2024-25 Design, Build, Fly Q&A #3

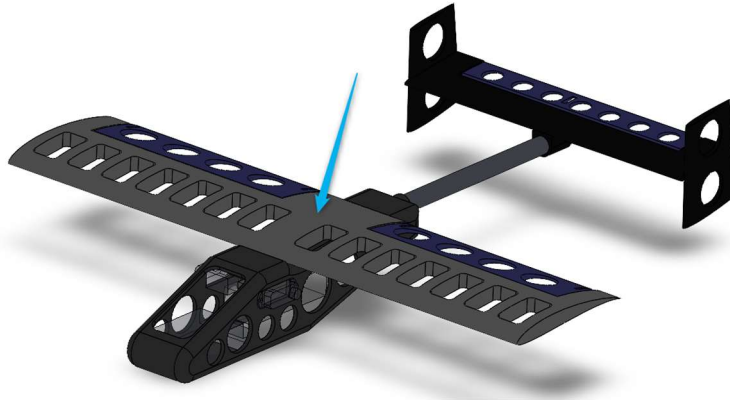
8. If the wing is mounted flush on top of the fuselage like the example shown in the image below, is the section directly above the fuselage (denoted with the blue arrow) considered part of the wing and subject to said clearance rule, or part of the fuselage and exempt from the rule?

Answer: In the example shown, the wing aero profile extends across the top of the fuselage and is therefore subject to the 0.25 inch clearance rule. If the release mechanism connects to the wing, it must extend a minimum of 0.25 inches away from the fuselage to be compliant.

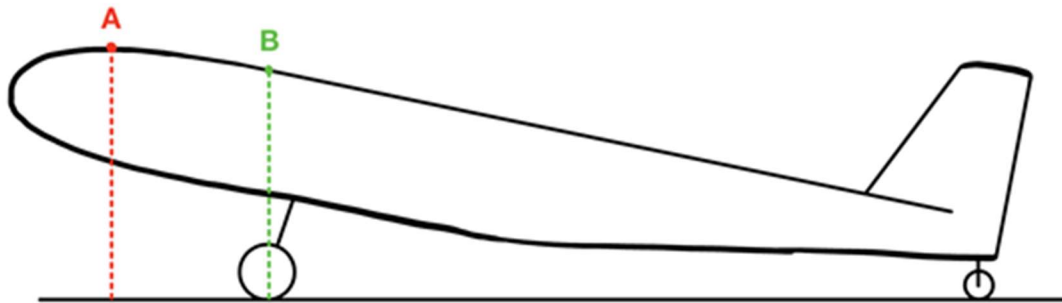
13. The rules state that for Ground Mission, "blocks cannot exceed the height of the airplane fuselage from the ground while resting on its landing gear" but our fuselage rests at an angle. Will this height be defined as the height of the fuselage when it is parallel to the ground (and resting only on its main gear) or sitting at an angle (on its main gear and tail wheel). If it is the latter, at what point along the fuselage will the "height be measured to: point A, point B, or some other point? (see image below)?

Answer: The rules clearly state "while resting on its landing gear", which means ALL gear and contact points (in the case a rear tail skid is used in place of a wheel). In the example provided, the maximum height of the blocks cannot exceed point "A".
